MILITARY SPECIFICATION

CONNECTORS, ELECTRIC, RECTANGULAR, MINIATURE POLARIZED
SHELL, RACK AND PANEL.

This amendment forms a part of Military Specification MIL-C-24308B, dated, 20 May 1983, and is approved for use by all Departments and Agencies of the Department of Defense.

FIGURE 3. Contact pin strength.

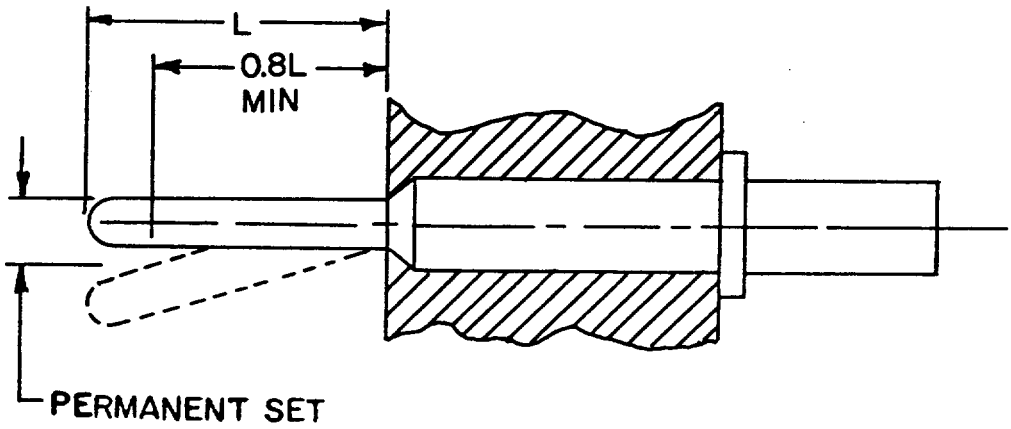
* FIGURE 3, delete and substitute new figure as printed on page 3 of this amendment.

Mating end size	Moment (lb-in.) (unless otherwise specified (see 3.1)
20	.53
22	.22
23	.16
24	.13
